# Transmitter Overshoot Penalty

(Comments 108, 109, 110, and 111)

Ali Ghiasi - Ghiasi Quantum/Marvell

IEEE 802.3dj Interim Meeting  
Austin

# Over/under-shoot Definition

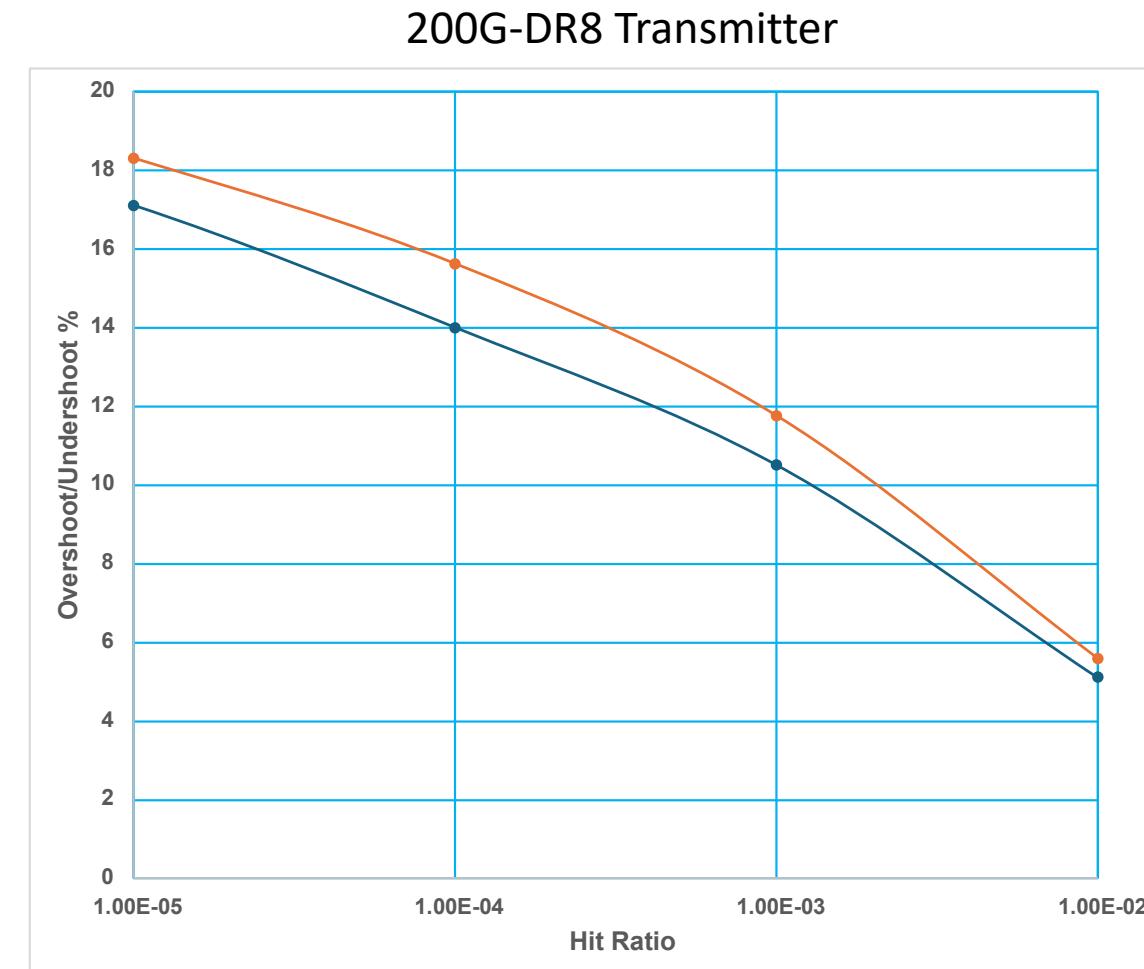
- Over/under-shoot is defined at  $10^{-2}$  hit ratio and maximum limit of 22%

- PAR penalty and ADC clipping may manifest itself at the extreme of scramblers and can be infrequently
- Even for SSPRQ moderate size pattern (65,535 bits ) overshoot triples from ~5% at hit ratio of  $10^{-2}$  to ~15% at hit ratio of  $10^{-4}$ 
  - A typical transmitter with 15%, 20%, or 22% overshoot at  $10^{-2}$  hit ratio can be problematic!

- ❑ **As part of effort to improve interoperability and reducing link flaps better management of overshoot/undershoot is needed**
  - Comment 261, 262, 263, and 264 recommends reducing overshoot from 22% to 12%
    - The overall benefit of enabling DFE is much greater than reducing the overshoot from 22% to 12%
    - Generally, 10% overshoot is sufficient for DR/FR optics but one supplier has suggested overshoot of ~16% is for LR4 links based on EMLs
- ❑ **Given TDECQ decreases with increasing overshoot as the BER degrades may result in transmitter optimization where link BER is 2-3 order of magnitude worse and FRx is passing**
  - Excess overshoot may cause ADC clipping even-though such events are infrequent, but when it happens likely will result in link flap
  - Longer term one option is to incorporate PAR penalty into TDECQ assuming assuming an ADC ENOB of 6 bits.
